MONTGOMERY COUNTY HISTORIC PRESERVATION COMMISSION
STAFF REPORT

Address:	21 Grafton St., Chevy Chase	Meeting Date:	10/28/2020
Resource:	Contributing Resource Chevy Chase Village Historic District	Report Date:	10/21/2020
Applicant:	Duane and Paula Gibson	Public Notice:	10/14/2020
Review:	HAWP	Tax Credit:	No
Case Number:	35/13-20BB (REVISION)	Staff:	Dan Bruechert
PROPOSAL:	Front Stairs, Rear Patio, and Accessory Building Modifications (RETROACTIVE)

Figure 2: detail of September 9, 2020, approved front stair proposal.

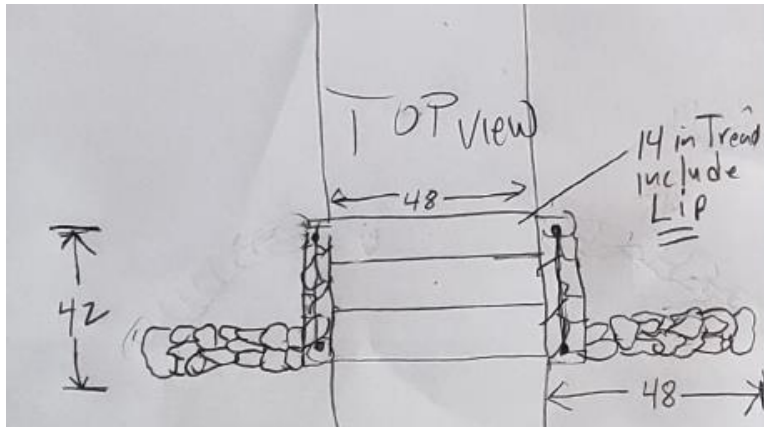
The existing front walkway, which runs from the sidewalk to the house and along the front of the house, is constructed out of bricks set in mortar. The applicant proposes to remove the existing walkway and install a walkway in matching dimensions using flagstones. The approved retaining wall at the intersection between the walkway and the sidewalk turned at right angles (see below).

The applicant now proposes to have the sides of the retaining wall extend in quarter rounds (see below). The change in shape will not require additional re-grading on the site.

Staff finds that stonework matches the treatment of the front porch piers and is an appropriate material. Staff further finds that while the proposed retaining wall will project further, its new form requires less alteration on-site, because no backfilling will be needed. Staff recommends the HPC approve the front walkway retaining wall alteration under the *Design Guidelines, Chapter 24A-8(b)(2) and (d)*.
